HOLTEC INTERNATIONAL
HI-STORM 100 CASK SYSTEM
AMENDMENT NO. 1
SAFETY EVALUATION REPORT

Figure 4.1 The effect of thickness reduction due to oxidation of the PWR cladding on the stress.

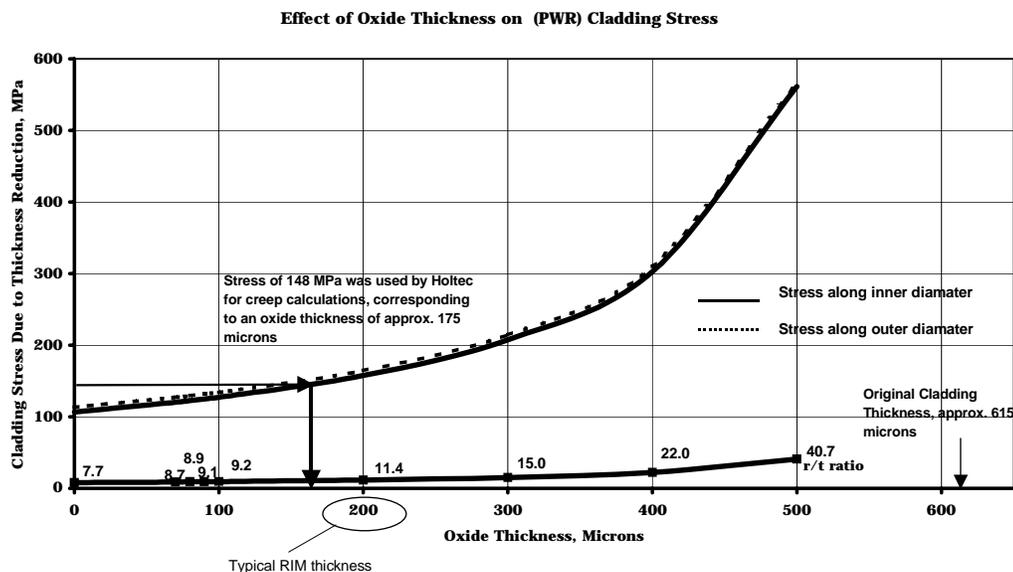
For the PWR fuel cladding, for an internal pressure of 2,000 psi at the start of storage, a radius to thickness ratio of 10.5 was used to determine the cladding stress of 144.7 MPa. Staff has

determined that this value corresponds to an oxide thickness of approximately 175 microns, as shown in Figure 4.1.

Thus, by eliminating the oxide outer layer, the applicant uses a higher stress value for the cladding, as if approximately 175 microns of oxide layer has been removed from the total metal thickness. Considering that the experimentally verified (Figure 4.A.13 in Appendix 4-A of the Holtec SAR) cladding oxide thickness varies between 100 to 140 microns at a burnup of 60 GWd/MTU, the staff has concluded that the applicant's approach has included reasonable conservatism in its analyses.

Figure 4.2 The effect of thickness reduction due to oxidation of the BWR cladding on the stress.

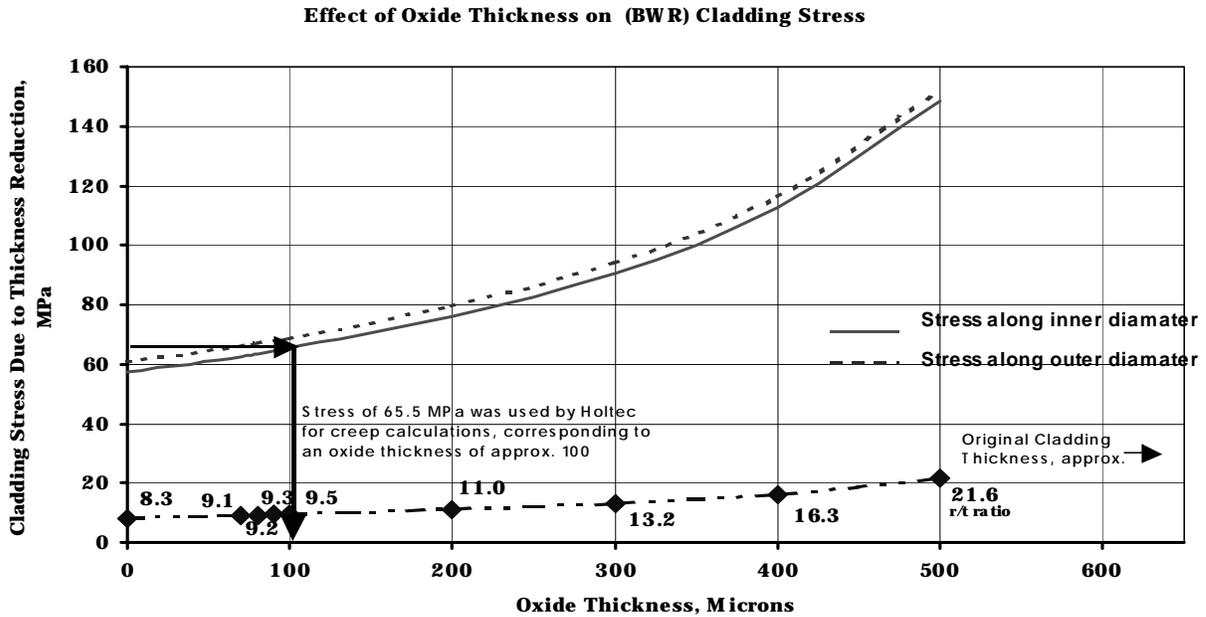
For the BWR fuel cladding, for an internal pressure of 1,000 psi at the start of storage, a radius to thickness ratio of 9.5 was used to determine the cladding stress of 65.5 MPa. Staff has determined that this value corresponds to an oxide thickness of approximately 80 microns, as shown in Figure 4.2. Thus, by eliminating the oxide outer layer, the applicant uses a higher stress value for the cladding, as if approximately 80 microns of oxide layer has been removed from the total metal thickness. Experimental data have not been provided for cladding oxide thickness as a function of burnup for the BWR fuel cladding. However, considering the less severe potential for oxidation in BWR, when compared to PWR, the staff has concluded that the applicant's approach has included reasonable conservatism in its analyses.
